ADDENDUM NO. 1

PROJECT: Three Mile WMA Wheelbarrow Creek Bridge Replacement

FWP PROJECT #: 23-03

DATE: 3/10/2023

PERMANENT LOG WEIRS

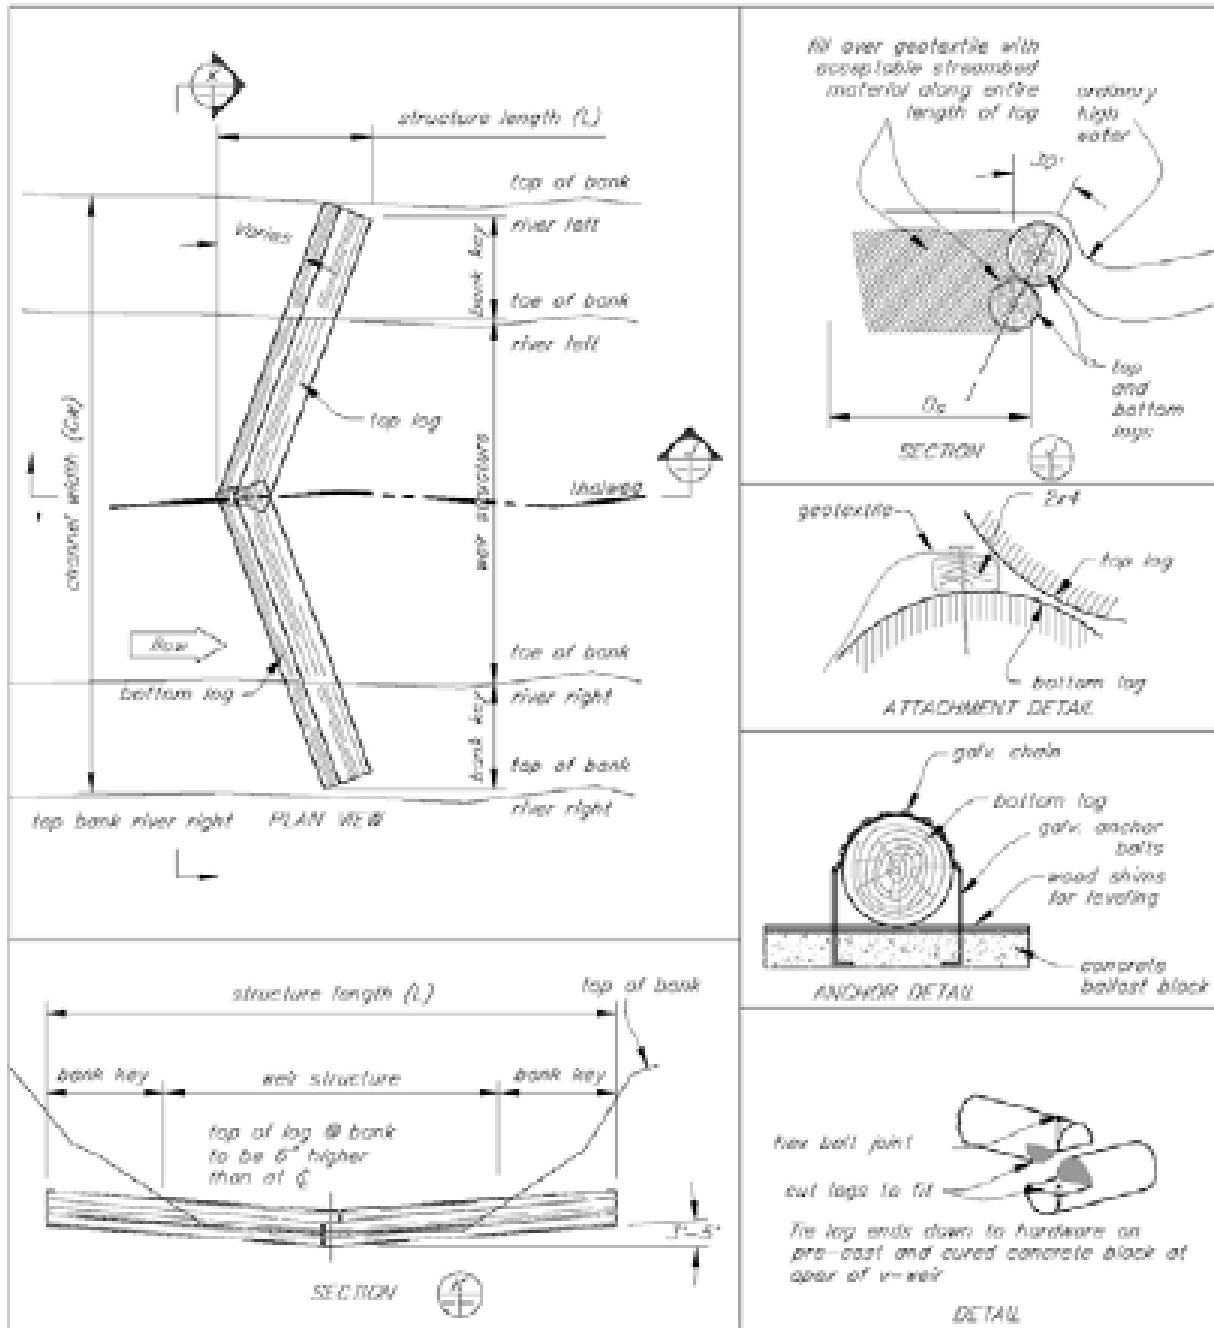
- Add grade control structures to bridge installation bid Item # 1.

One or more logs or timbers spanning the entire stream, and long enough to pass bankfull flow (at a minimum) between the banks. Logs may be pinned together, or cabled or chained to ballast—a large, heavy object buried in the streambed or bank that acts as an anchor keeping the logs from floating

away. Like rock and concrete weirs, log weirs should have a low-flow notch or slope toward the middle of the channel. Constructing them in a V-shape in cross section and plan view (V pointing upstream) forces water to converge in the channel center, and reduces the tendency to accumulate sediment and become vulnerable to outflanking.

To facilitate upstream fish passage, construct log (like rock) weirs in steps no higher than 5 inches of drop so local fish can jump.

Installing no fewer than six (6) log weirs in series.

Excavate the area around the existing culvert to the native material resembles a native streambed. The stream bed should consist of cobbles and sandy material. See bridge plans for more details on the cross section shape of the stream.

Logs should be a minimum of 8" in diameter and 4 feet long. Logs can be locally sourced and be untreated.

Labor and materials are to be included in the installation of the bridge bid item.
